**Ref.** Goose Project

**Subject** Water Licence No: 2AM-BRP1831 (Amendment No.1) – Modification and Management Plan Updates

FIGURE 2 GOOSE MINE AREA - POTENTIAL DEVELOPMENT AREA AND LAYOUT

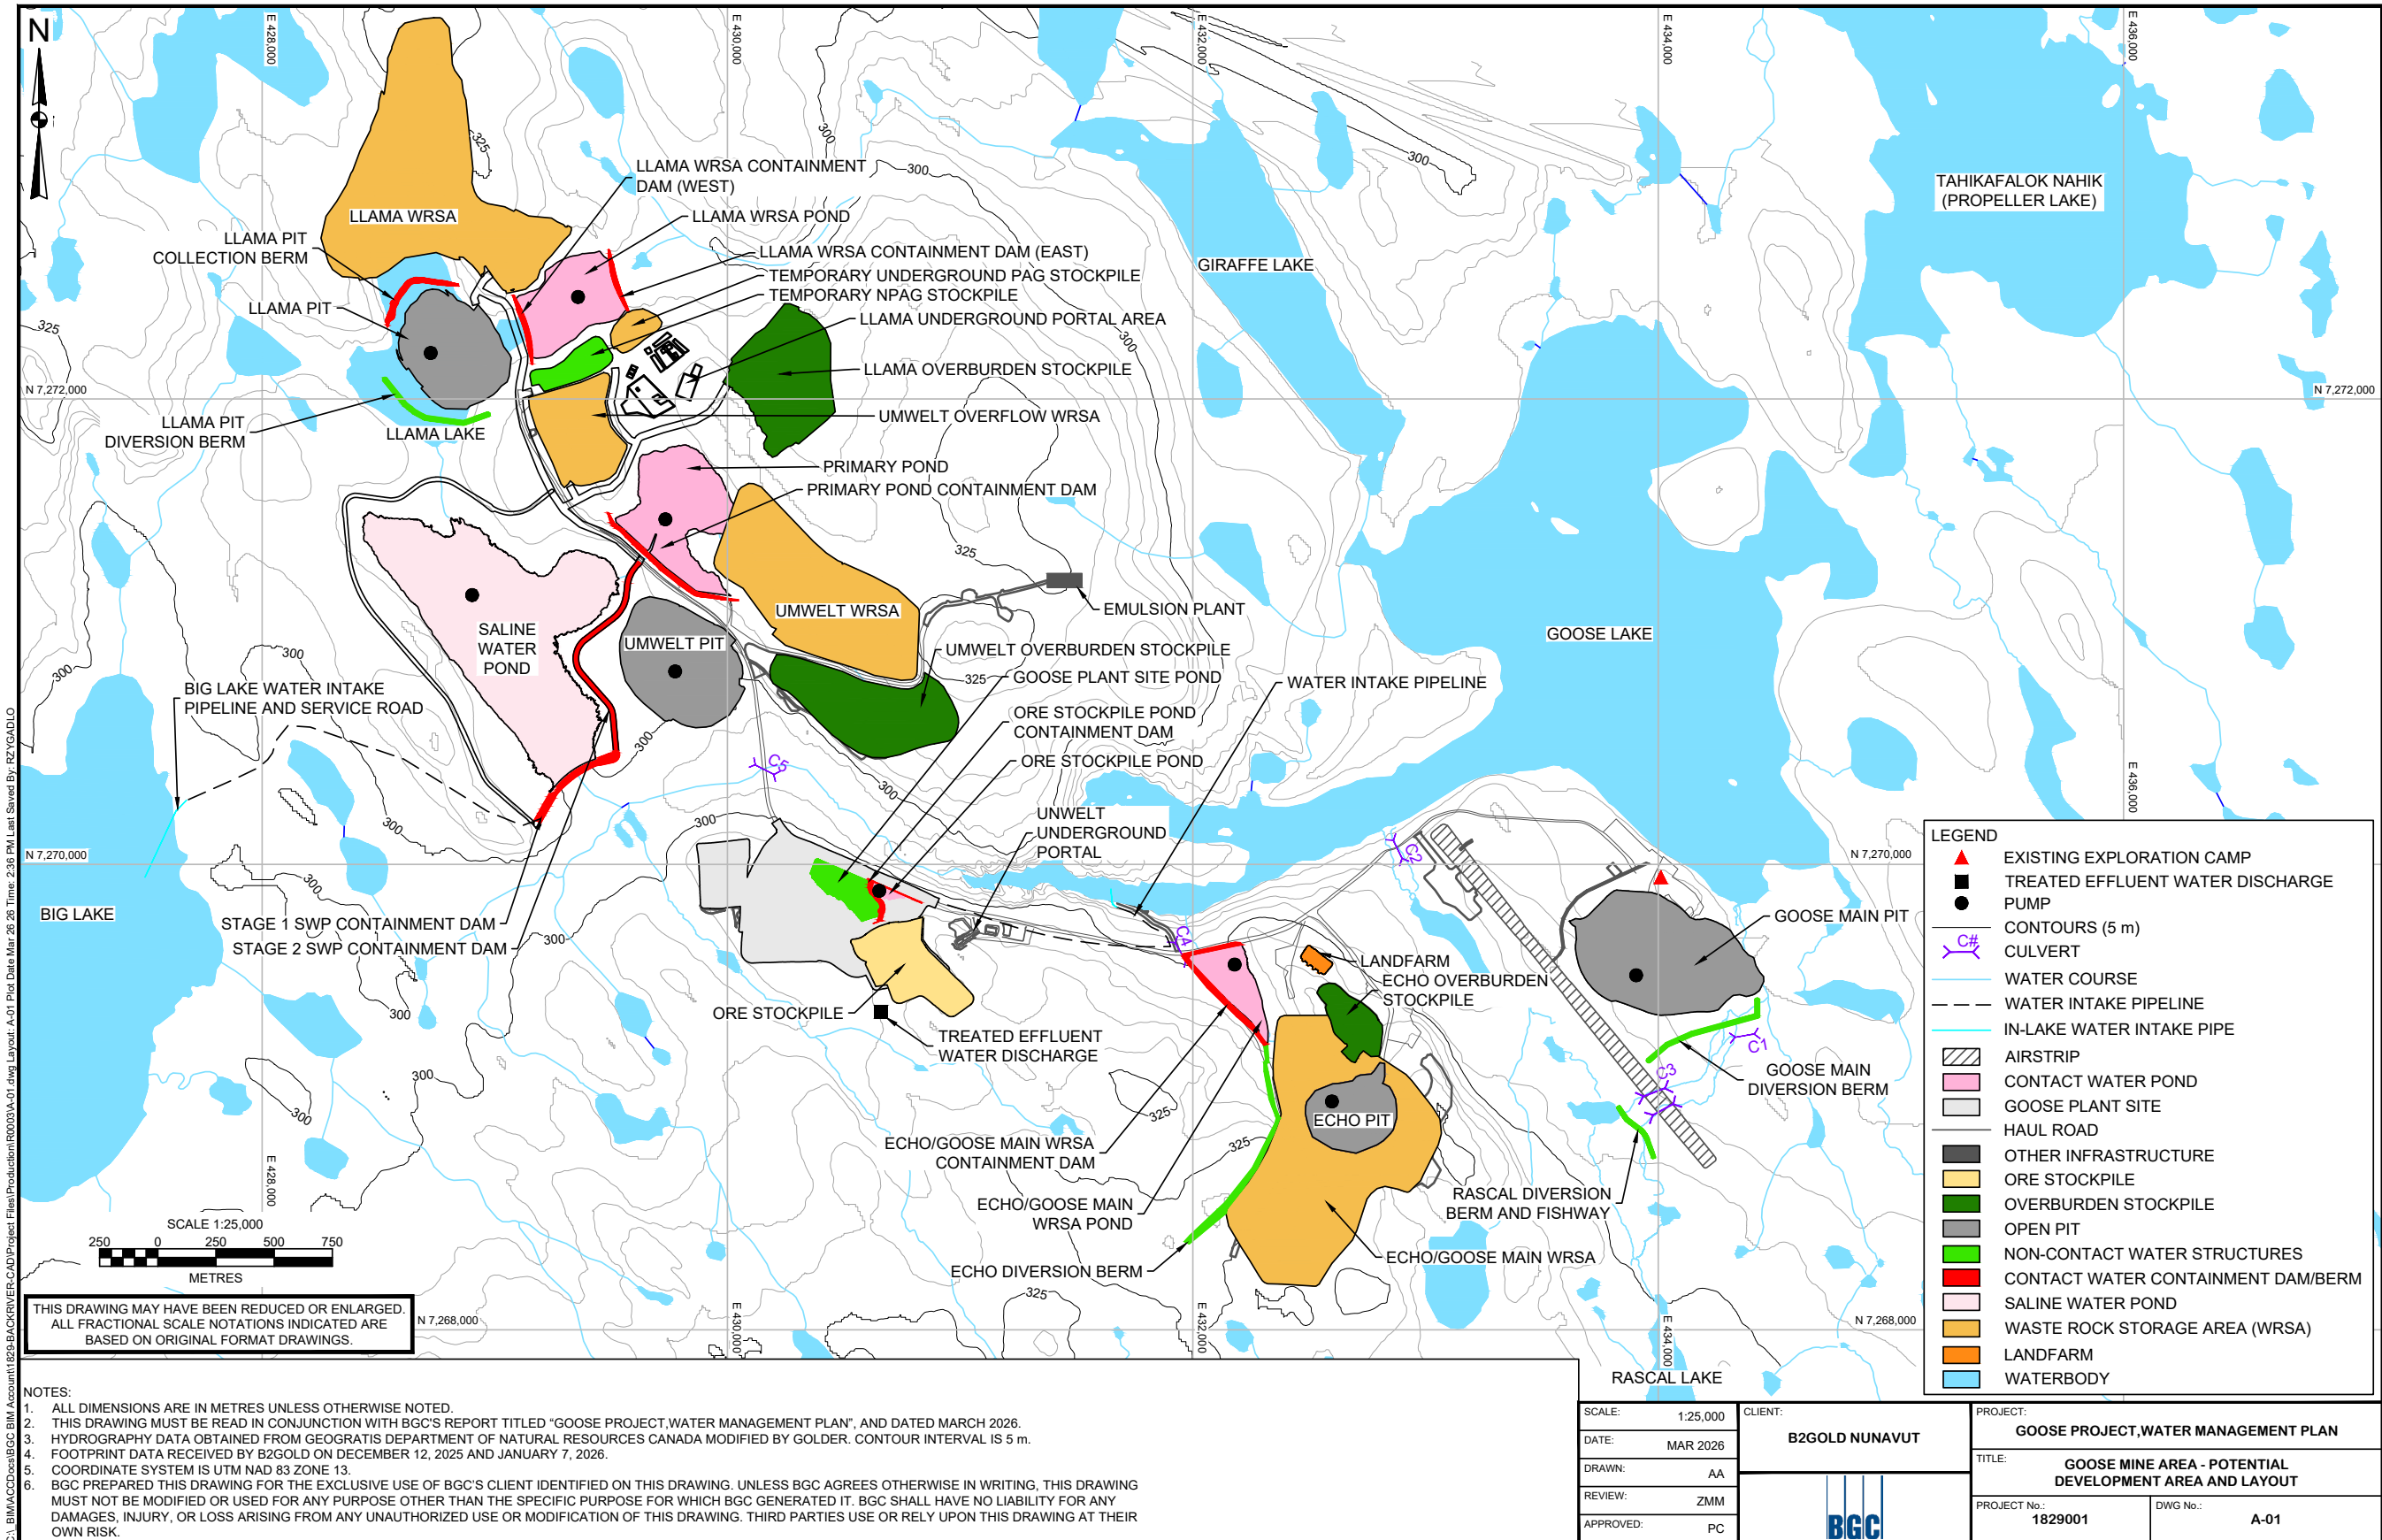
B2Gold Nunavut has updated the mine development sequence in a manner that provides for more efficient operations. Minor adjustments are proposed to some of the WRSAs, water management facilities, access roads, and related operational facilities at the Goose Mine. No changes are proposed to the Allen Kapolak Marine Laydown Area or the connecting Winter Ice Road.

- ◆ Adjustment to the location and dimensions of the Llama WRSA (Figure 5.1-1; Attachment A Waste Rock Management Plan, Section 5.4.1.3)
  - ◇ The Llama WRSA will have an area of approximately area of 59 ha, have a height of approximately 110 m, and will be located north of the Llama Open Pit.

- ◆ Adjustment to the location and dimensions of the Umwelt WRSA (Figure 5.1-1; Attachment A Waste Rock Management Plan, Section 5.4.1.1)
  - ◇ The Umwelt WRSA will have an area of approximately 38 ha, have a height of approximately 80 m, and will be located east of the Umwelt Open Pit.

- ◆ Addition of Umwelt Overflow WRSA (Figure 5.1-1; Attachment A Waste Rock Management Plan, Section 5.4.1.2)
  - ◇ A supplementary waste rock storage area for both the Umwelt and Llama pits.

- ◆ Addition of two temporary waste rock stockpiles (Figure 5.1-1; Attachment A Waste Rock Management Plan, Section 5.4.1.5):
  - ◇ Temporary NPAG Stockpile

- ◇ Temporary Underground PAG Stockpile, material relocated underground as operational backfill
- ◆ Minor adjustments to the dimensions and timing of open pits and underground developments (Section 8.2.3, Attachment B Water Management Plan)

- ◆ Addition of three overburden stockpiles (Figure 5.1-1; Attachment A Waste Rock Management Plan, Sections 5.4.1.6 and 5.4.1.7):
  - ◇ Umwelt Overburden Stockpile

- ◇ Llama Overburden Stockpile
  - ◇ Echo Overburden Stockpile
- ◆ Minor changes to roads and pads (Figure 5.1-1 Attachment A Waste Rock Management Plan,)

The proposed modification components are shown in Figure 2, drawing number A-01 from the Water Management Plan (Attachment B).
